**CITY OF CARMEL-BY-THE-SEA  
PLANNING COMMISSION  
MEETING AGENDA**

February 14, 2018  
Wednesday  
Tour: 2:00 p.m.  
Meeting: 4:00 p.m.

2. DS 17-441 (Lasher)  
Holdren Lietzke Architecture, Architect  
Camino Real, 3 NE of 13th Ave  
Block: AA; Lot: 18  
APN: 010-281-013  
Consideration of a Final Design Study (DS 17-441) and associated Coastal Development Permit for the demolition of an existing residence and construction of a new 1,800 square-foot two-story residence located in the Single-Family Residential (R-1) Zoning District. **(p. 14 )**

**A1.1**  
30

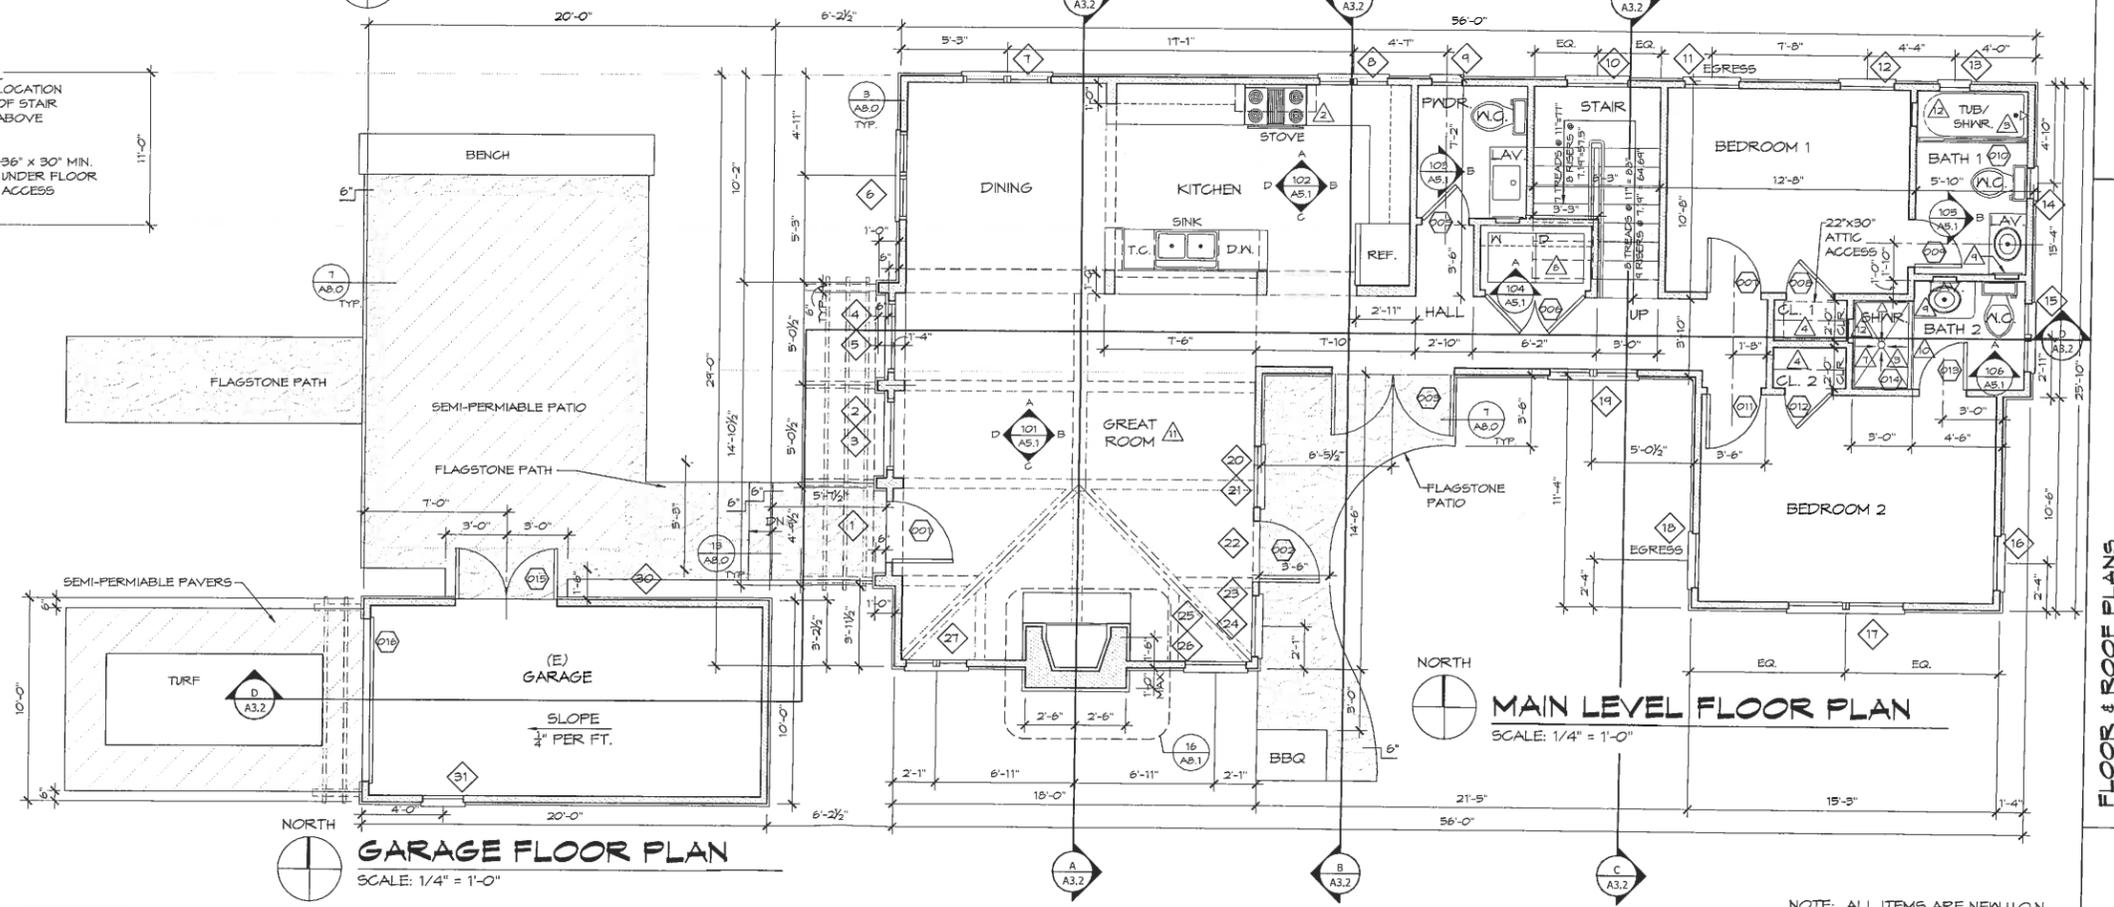
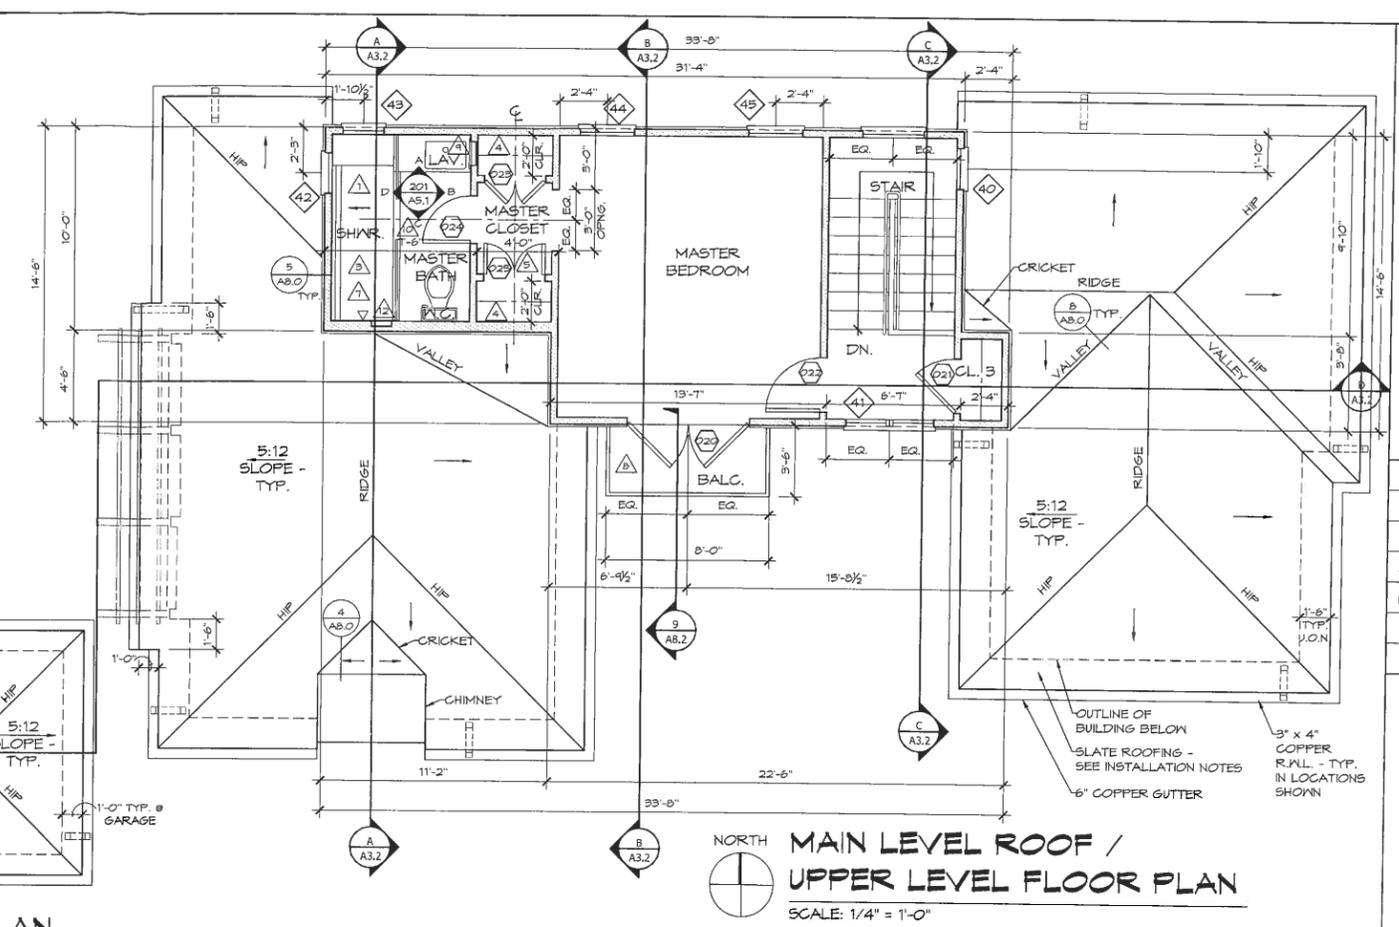
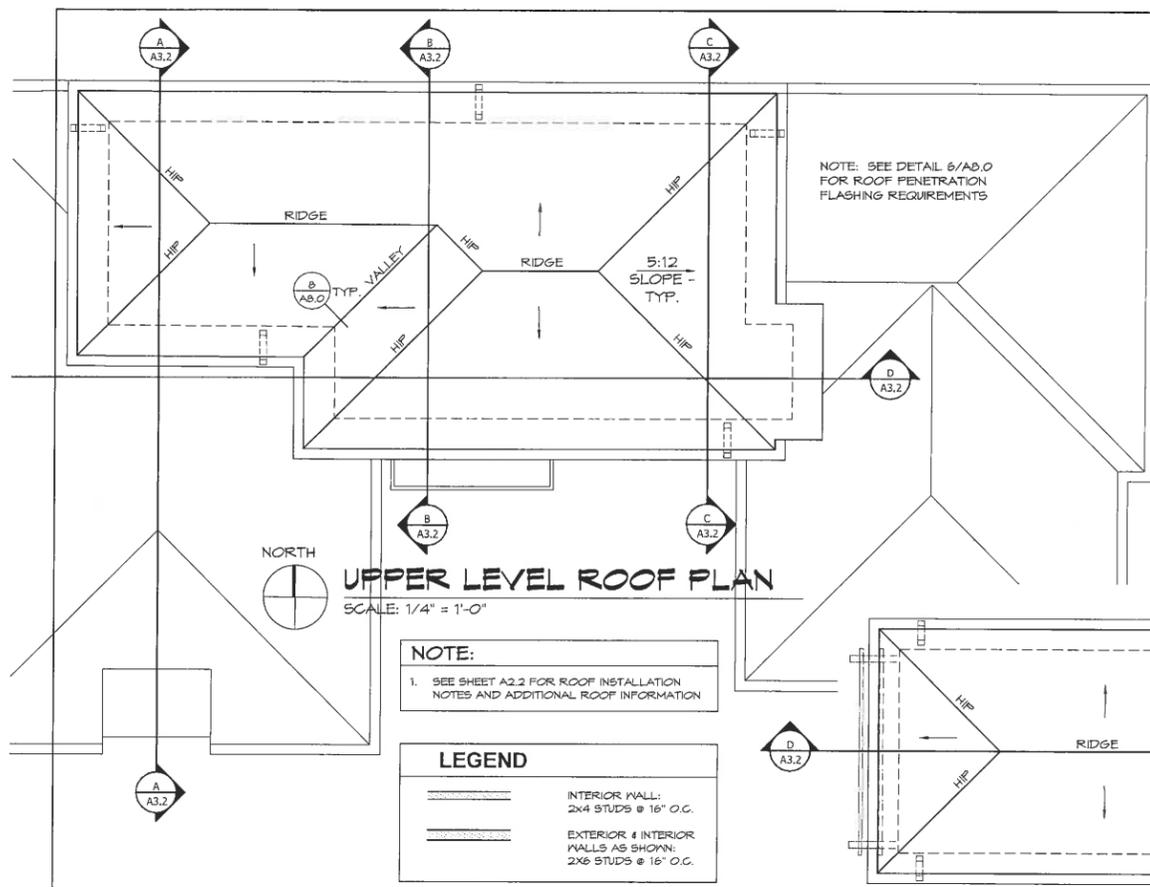
2. *The applicant shall remove the fireplace from the 10-foot composite side-yard setback.*

Staff Analysis: The applicant has complied with this requirement and has moved the proposed stone and stucco fireplace outside of the 10-foot composite side-yard setback as shown on sheet A1.1 of the plans.
